**Symptom - Engine - Engine is Sluggish When Revving Up/Maximum Speed is not Reached:
Checking Part Number of Throttle-Housing Cover (SY 104/19)**

Vehicle Type: **911 GT3 Touring (991)**

Concerns: **Throttle-housing cover**

Throttle-housing cover

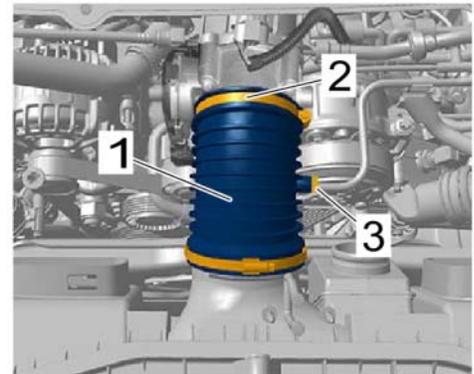
Cause: In the case of 911 GT3 **Touring** vehicles, the cover between the air cleaner housing and throttle housing can become deformed due to insufficient material hardness while driving.

Work Procedure: 1 Check part number ⇒ *Throttle-housing cover -1-*.

- 1.1 Replace throttle-housing cover with Part No. **99111027091**, see ⇒ *Workshop Manual '242519 Removing and installing air cleaner housing'*.
